14-26 COMMERCIAL ROAD KINGSGROVE REVIEW OF NEW M5 PROJECT ENVIRONMENTAL IMPACT ASSESSMENT (EIS)

REVIEW OF WESTCONNEX M5 STAGE 2 PROJECT INFORMATION AND EIS

Figure 6 – M5 East bound tunnel longitudinal section (Source: EIS Appendix C)

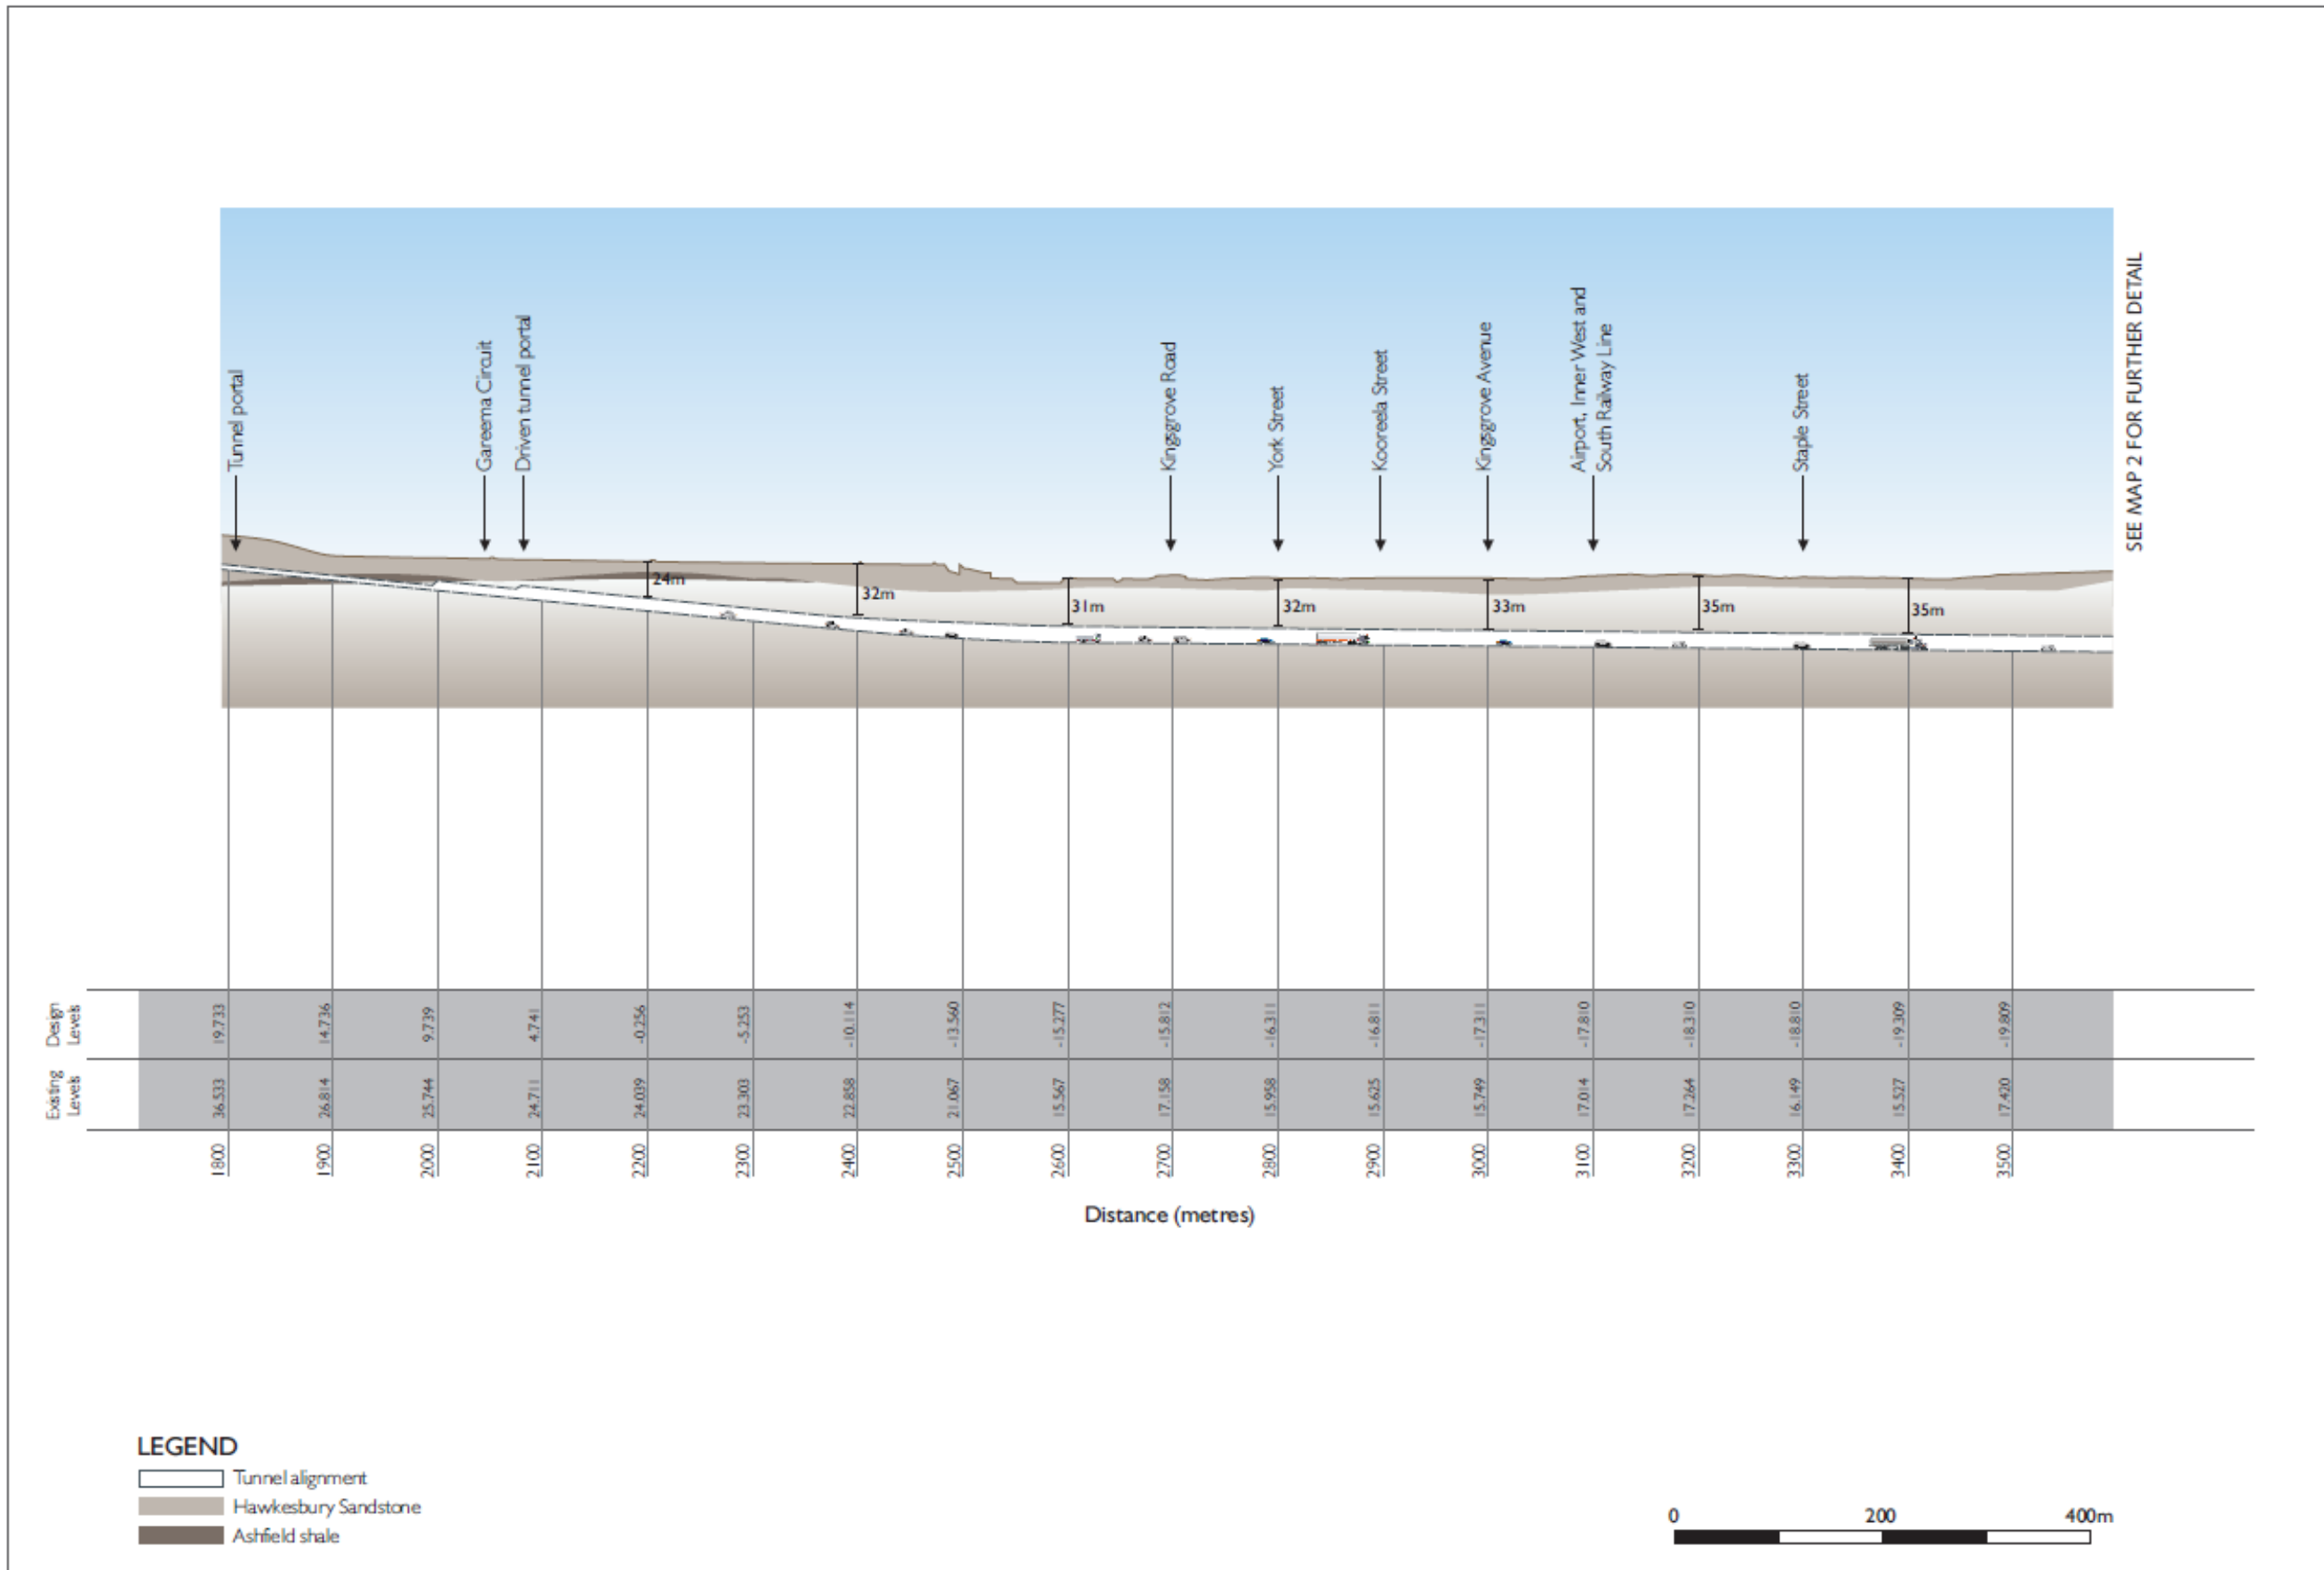
We note however the EIS shows the west bound tunnel to be directly under your site as shown in Figure 2 and 4. Further the EIS shows the eastbound tunnel near your site to be about 30m below the surface as shown in Figure 6 (EIS Appendix C). However the Westconnex interactive map on their web site shows the tunnel to be about 10-18m below your site. Given this inconsistency in the information, we have called and sent an email to WDA to clarify this but have not got a reply as yet.

Whilst there are general plans showing the approximate 'plan' position of the tunnels, we have no dimensional information to use in our assessment. Further, we have conflicting information regarding the depth to the tunnels around the CRK site being from 10m to 30m.

Figure 8 – Sydney Water services

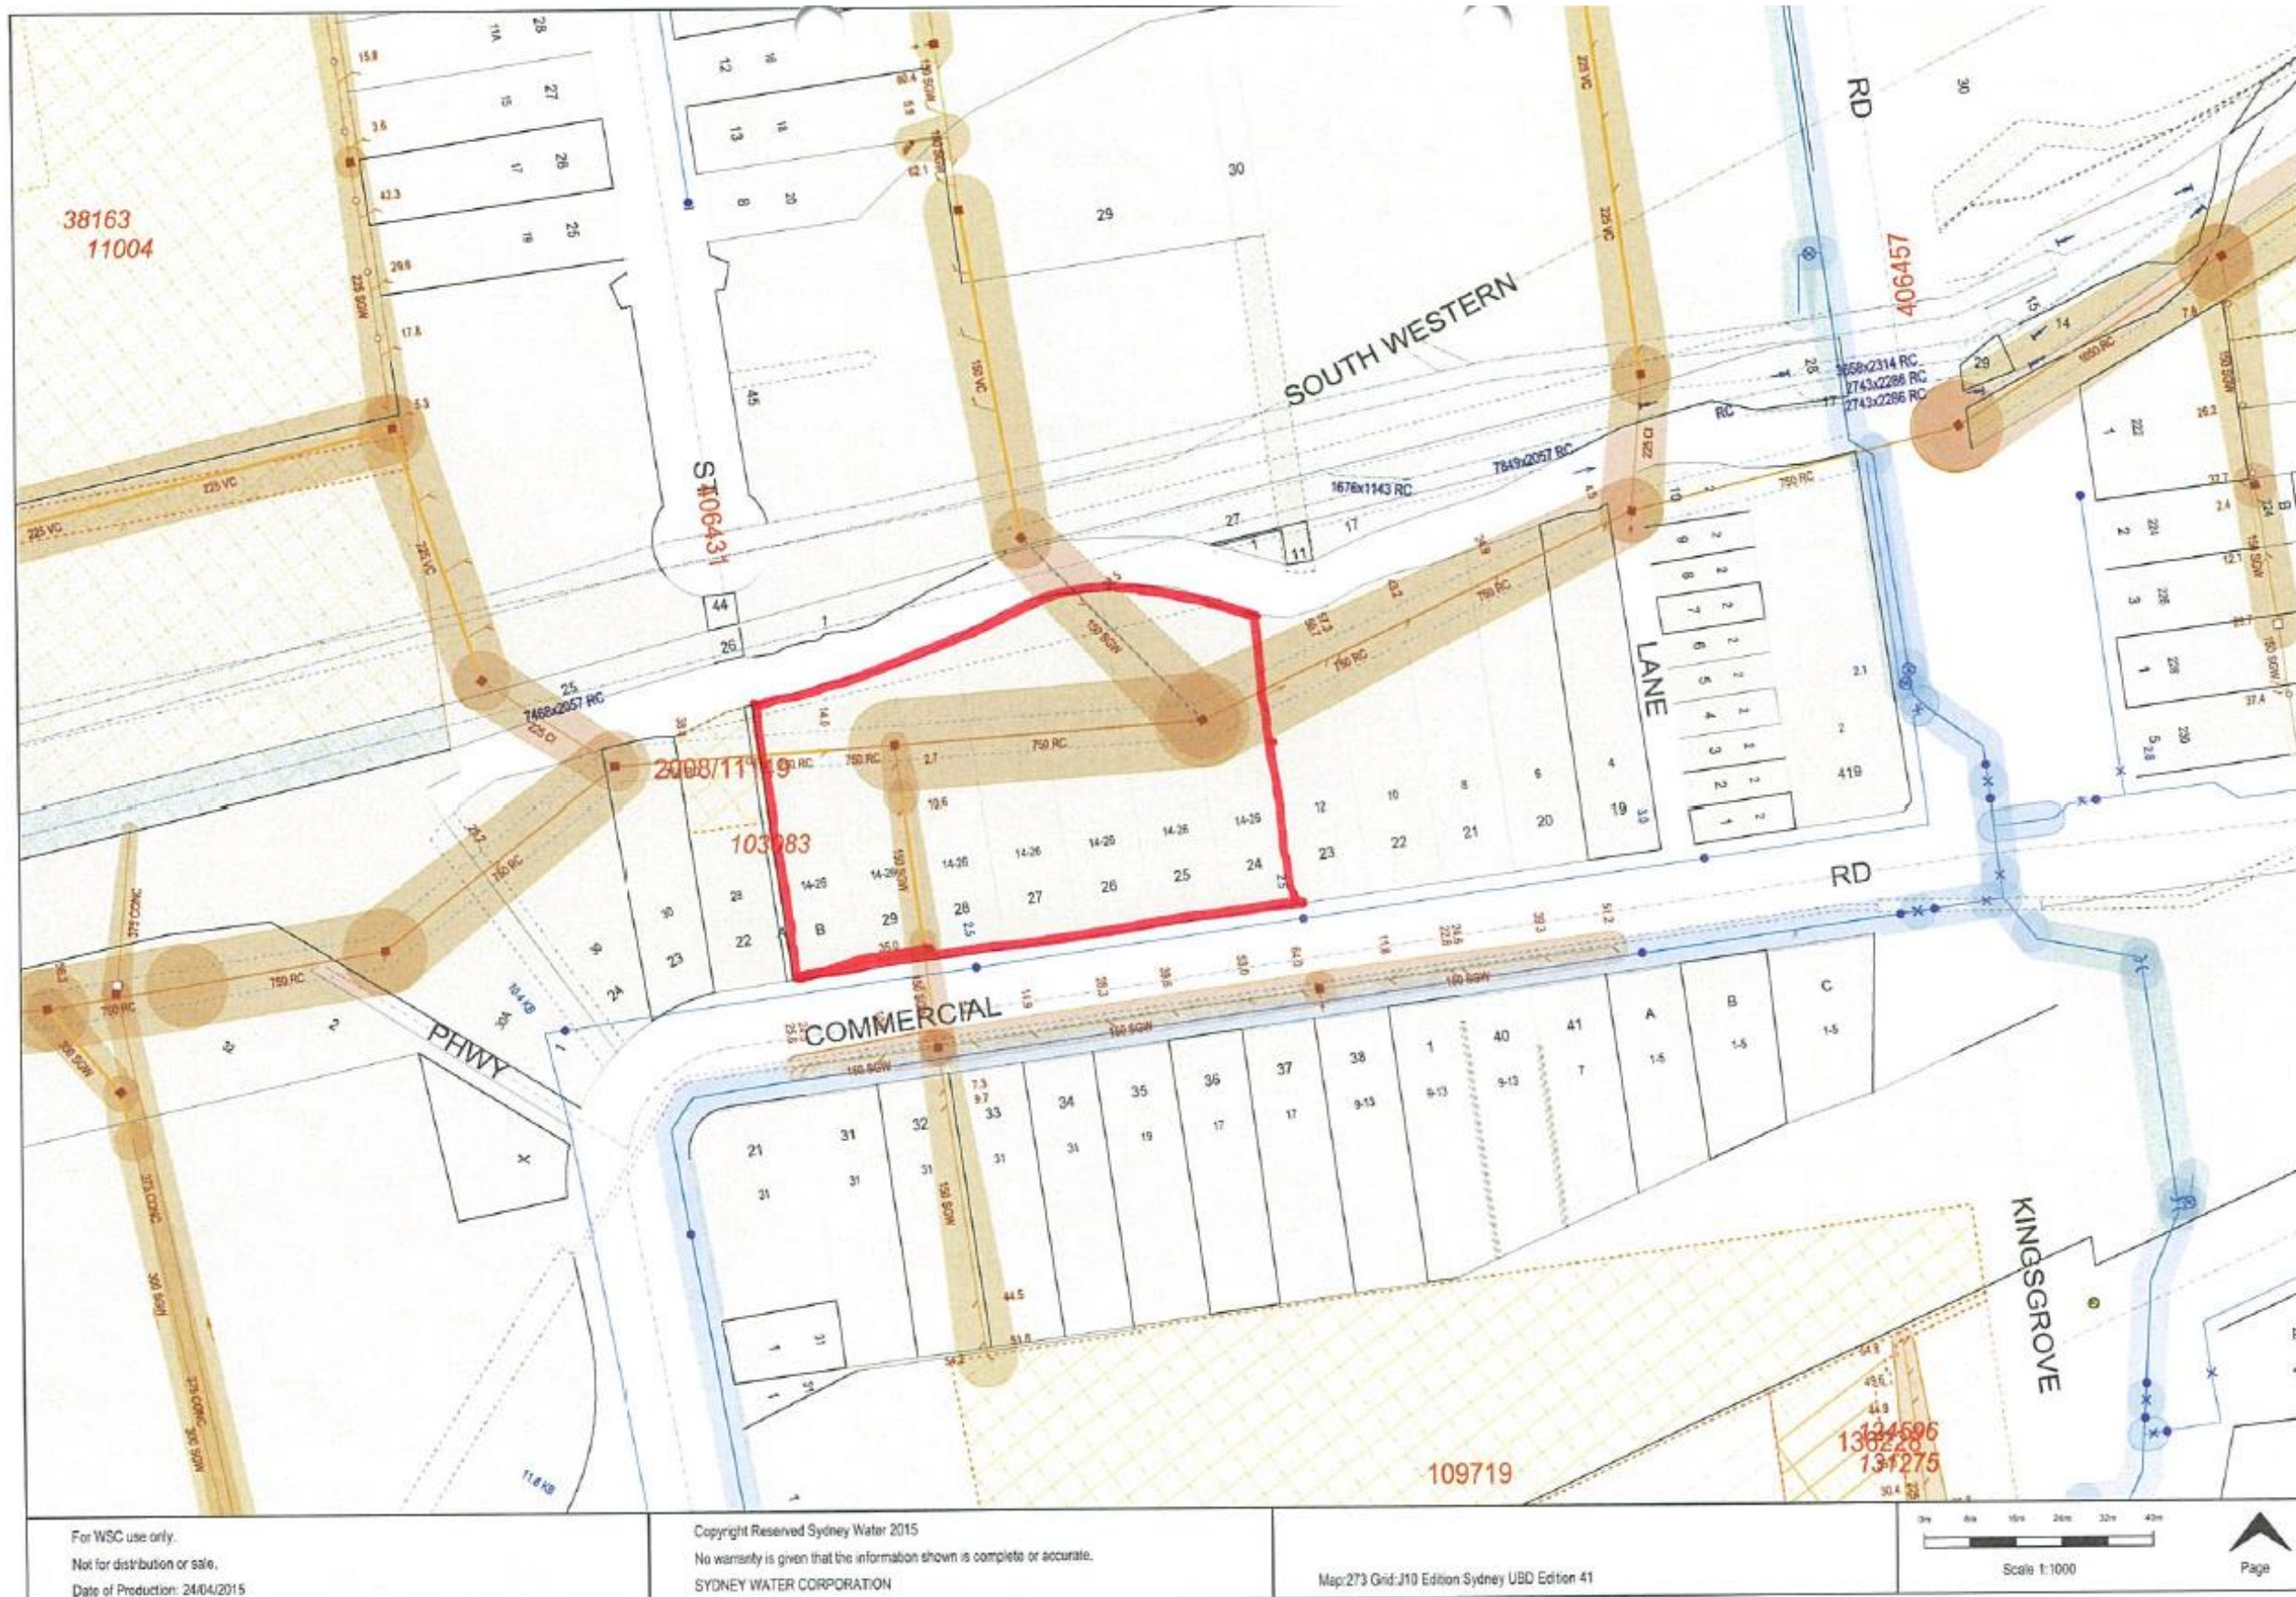
Figure 8 shows the Sydney Water plan and services. In particular we note the 750 RCP sewer mains which traverses the middle of the site. Please note that future development of this site main require the relocation or protection of the main subject to Sydney Water requirements or they may require the building to be suspended on piers over the main.

Figure 9 – Existing flood behaviour (100 year ARI)

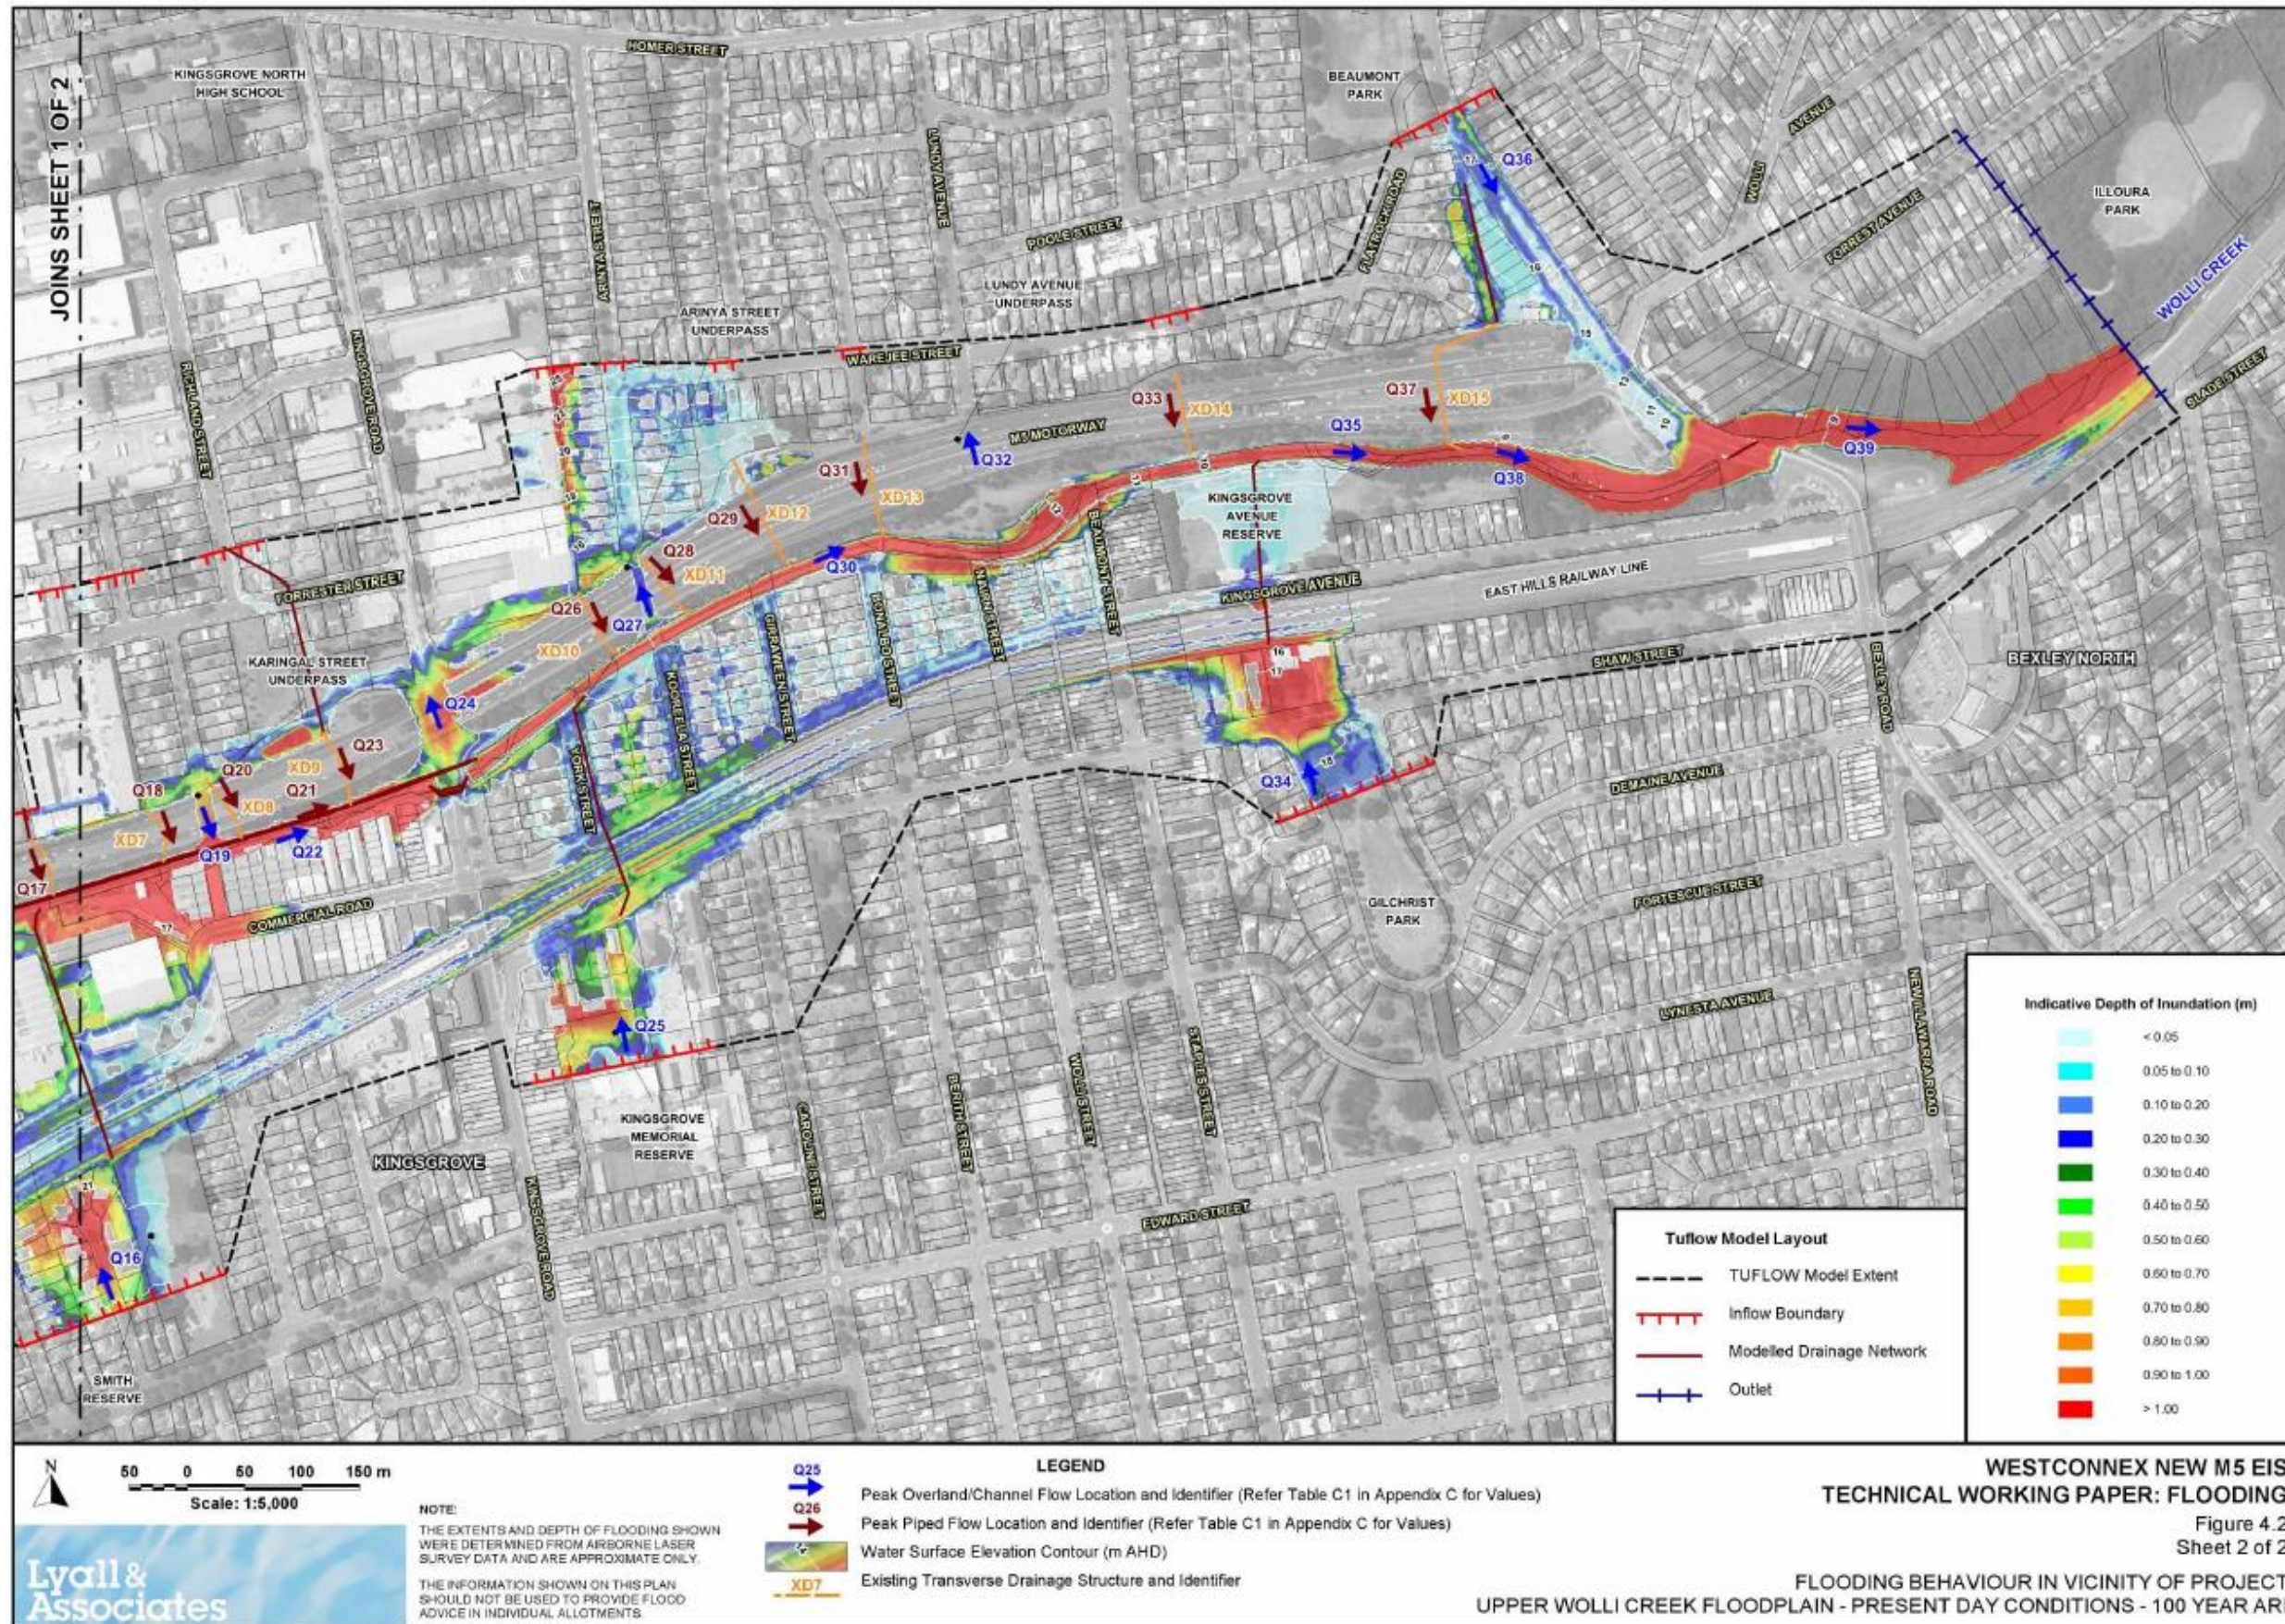
We note the site is located adjacent to a major stormwater channel as previously reported in our letter to you last year dated 18 June 2015. We note the site is also located in an existing flood zone as shown in Figure 9. WDA have modelled the proposed motorway works and indicated
